Development Outside the Red-Line Boundary and Separation from Undeveloped Land

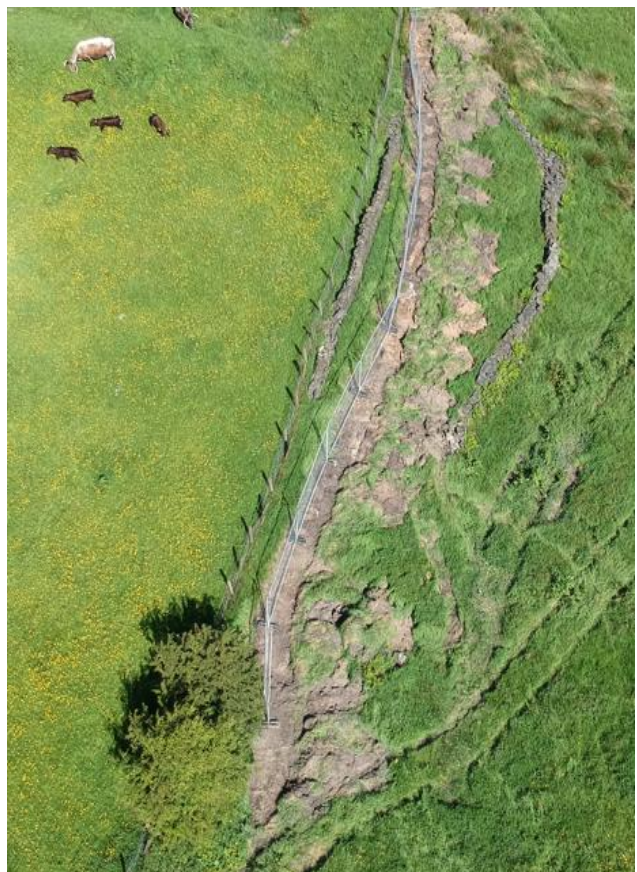
The earlier photograph (left) clearly shows a pre-existing wall running immediately outside the western red-line boundary. A later photograph (right) shows that this wall has been removed and that part of the land beyond its former position has also been excavated and regraded.

I am not aware of any planning permission authorising development on this land. As both the wall and the adjoining land appear to have been outside the application boundary, I ask the Council to establish whether its removal and the associated engineering/regrading works constitute a separate planning breach and, if not, to identify the permission or other planning authority under which those works were undertaken.

An earlier photograph shows that, while the pre-existing wall was still intact, land outside the red-line boundary had already been excavated and levelled to form a platform for construction fencing, with excavated material deposited alongside it. A later photograph shows the wall itself removed and further alteration of the adjoining land. These appear to be engineering works beyond the application boundary, for which I am unaware of any planning permission.

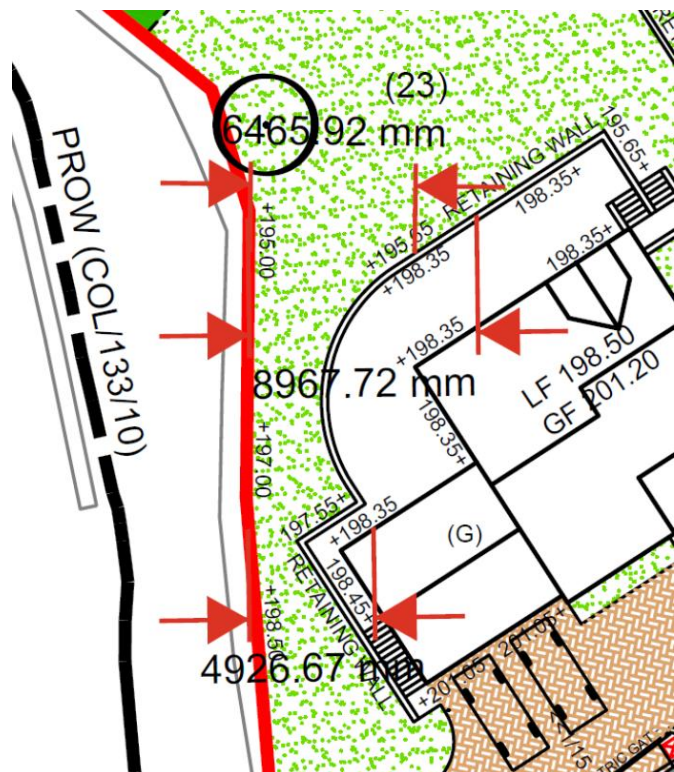
Earlier photographs identify the pre-existing stone wall outside the western red-line boundary. A subsequent photograph (right) records that wall being physically dismantled involving an excavator bearing the name **D.M. Brewster**, the principal contractor for the Lingards Fold development. This occurred on 7th April 2025.

I am unaware of any planning permission covering these works outside the application site. The photographic evidence therefore raises a reasonable concern that engineering works associated with the development have extended beyond the permitted red-line boundary. The Council should establish what planning authority, if any, permitted the wall removal and associated excavation/regrading before determining 2026/91657.
